INITIAL FIRE SAFETY INSPECTION REPORT

Croydon Kowloon Designs Ltd (Unit 2)

RSC ID: 26568

Date: 03-December-2025

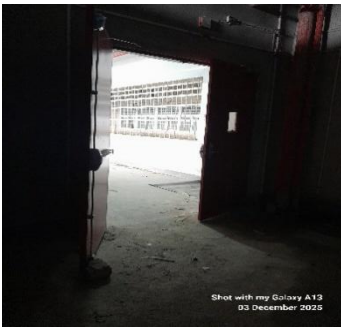
F-36	Fire Suppression System (SUPS)	Fire pump installation requires detailed review to confirm compliance with NFPA 20 and RSC Technical Guidelines (Standard)¹ V1.0. Location(s): All Buildings.	Submit as-built drawings, testing records, equipment certification and other relevant documentation to the RSC for review and approval. Submit the standpipe system drawing to RSC for review. Once reviewed, install or modify the standpipe system throughout the building in accordance with RSC Technical Guidelines (Standard)¹ V1.0. and NFPA 14 and 20. The factory management shall contact RSC to conduct the final acceptance testing after the installation, testing & commissioning.	Design within 2 Month and modification/ installation with 4 Months
